STOWE RIDGE SUBDIVISION, UNIT 1

DELTA LAND SURVEYING
104 WEST BAYOU STREET, SUITE 2
FARMERSVILLE, LA 71441
PHONE: 318-993-8090
PROJECT NO. 21-02-06-B
DATE: 2/23/2021
SCALE: 1" = 120'

RE: Stowe Ridge Subdivision, Unit 1 Review
Our File: 005-325

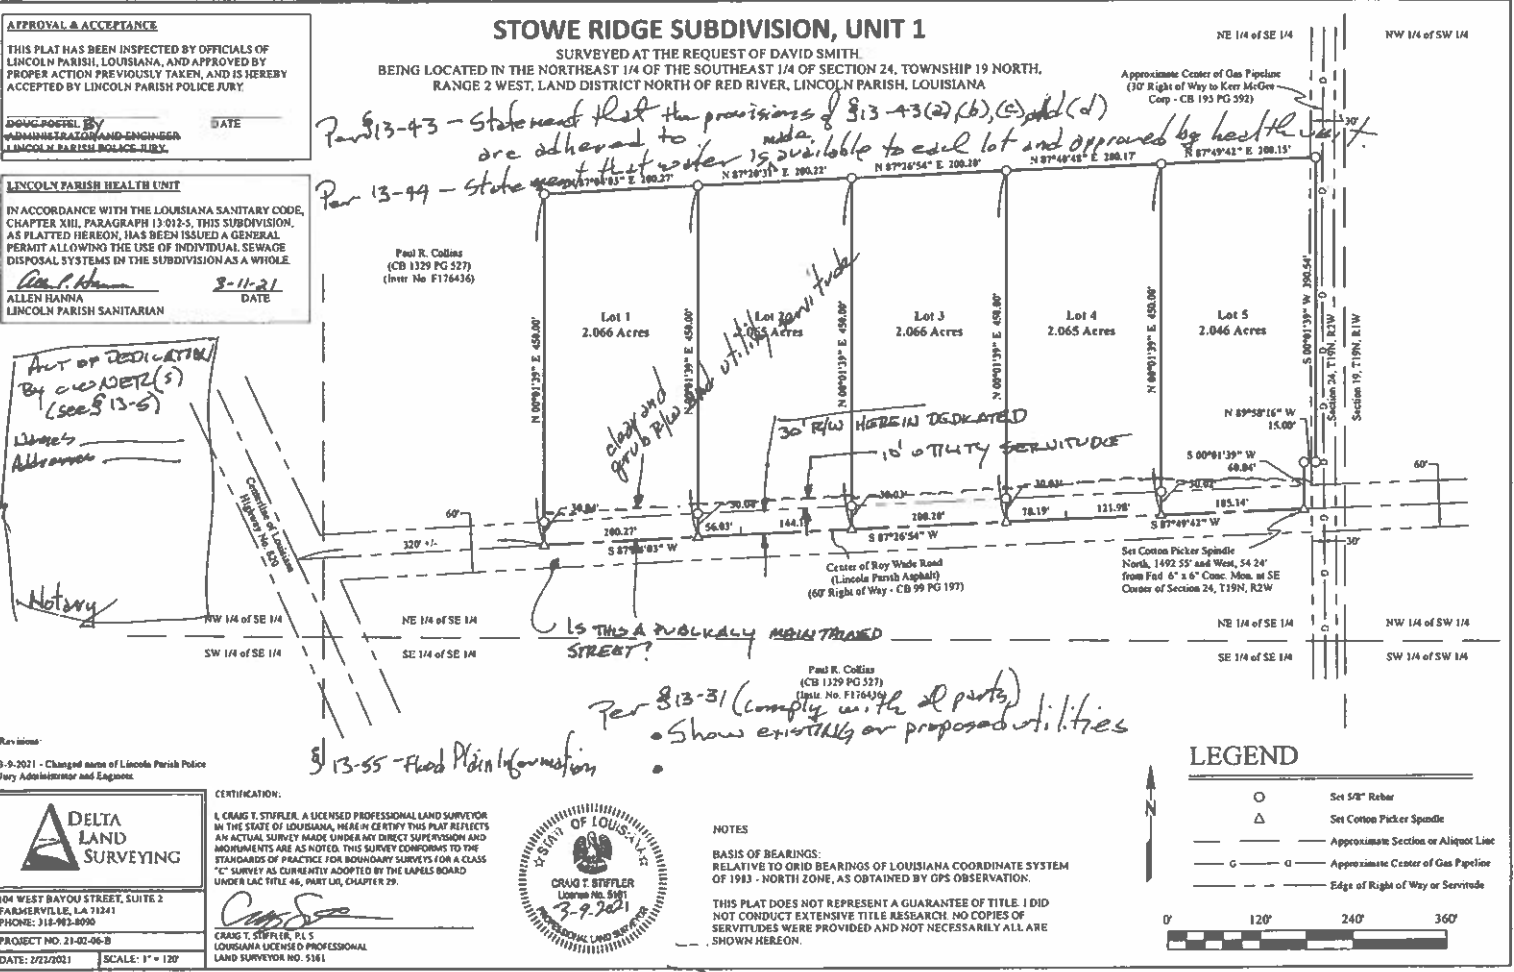
Par 13-43 - State must that the provisions of § 13-43(2)(b), (c), and (d) are adhered to
Par 13-44 - State must that water is available to each lot and approved by health unit.

Act of Dedication by owner(s) (see § 13-5)
Done's Address
Notary

- Per §13-5, include an Act of Dedication on the plat.
- Per §13-18, provide a 10' utility servitude across all lots fronting on Roy Wade Road.
- Show the width and type of construction of existing roads.
- Show existing and proposed utilities, lot lines, drainage, etc., including all requirements of §13-31.
- Per §13-43, add a statement that the provisions of §13-43 (a), (b), (c), and (d) will be strictly adhered to.
- Per §13-44, statement regarding the availability of water service, and provision for serving each lot.
- Per §13-55, statement regarding flood plain.
- Per §13-17(c), the street ROW and utility servitude shall be cleared and grubbed.
